RE: Deficiency Report #2, Salt Creek Substation Project Application for a Permit to Construct (A. 13-09-014)

DEFICIENCY REPORT #2 FOR THE SDG&E SALT CREEK SUBSTATION PROJECT APPLICATION (A. 13-09-014)

Exhibit 2 - SDG&E supplied visual simulation from Key View 7 using a 26mm equivalent focal length lens. The horizontal field of view for this photo is $\pm 80^{\circ}$. Note the vertical dimension of the street light pole and the existing monopole of TL 6913.

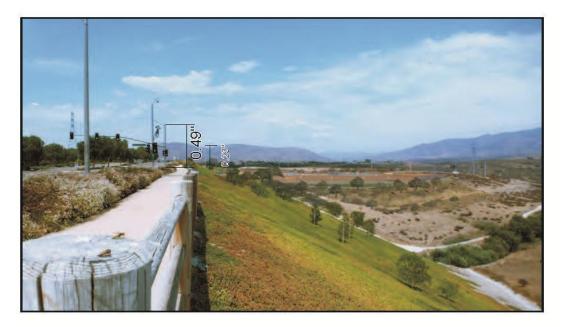
reality to the human eye. Exhibits 1 through 3 illustrate this point. Visual simulations

Exhibit 3 - Key View 7 showing a $\pm 40^{\circ}$ horizontal field that a 50mm equivalent focal length lens would capture. Note the vertical dimension of the street light pole and the monopole.

Table 1: SDG&E Salt Creek Substation Project Application A. 13-09-014 Deficiencies					
#	Deficiency #	Deficiency			
Aesth	Aesthetics				
1	DR-3.1	The photo simulations did not use industry-standard methods. Please prepare the simulations using current industry standards.			
		Visual simulations are used to analyze a proposed project's visual effects on the landscape. They also serve as a way to inform stakeholders of the expected project effects on private and public viewsheds. Visual simulation methodology is a science- based approach to accurately portray the baseline and post-project visual conditions. Visual simulations that do not adhere to industry-standard methodologies can lead to erroneous depictions of the project impacts on the visual environment, can bias the analysis, and are not defensible.			
		An important part of the simulation includes capturing representative photographic images of the project's baseline visual conditions. Before digital cameras became mainstream this was relatively straightforward because 35 mm film was the medium used to capture the images (35 mm horizontal and 24 mm vertical). Baseline photos were taken with a single-lens reflex camera with a 50 mm lens, representing a horizontal view angle of ±40 degrees. The 50 mm equivalent focal length (EFL) produces a 38.6° horizontal field of view (HFOV), which best represents the human visual perception (National Research Council 2007: 353). Further, this setting represents the normal human eye magnification and the primary view cone (excluding peripheral vision).
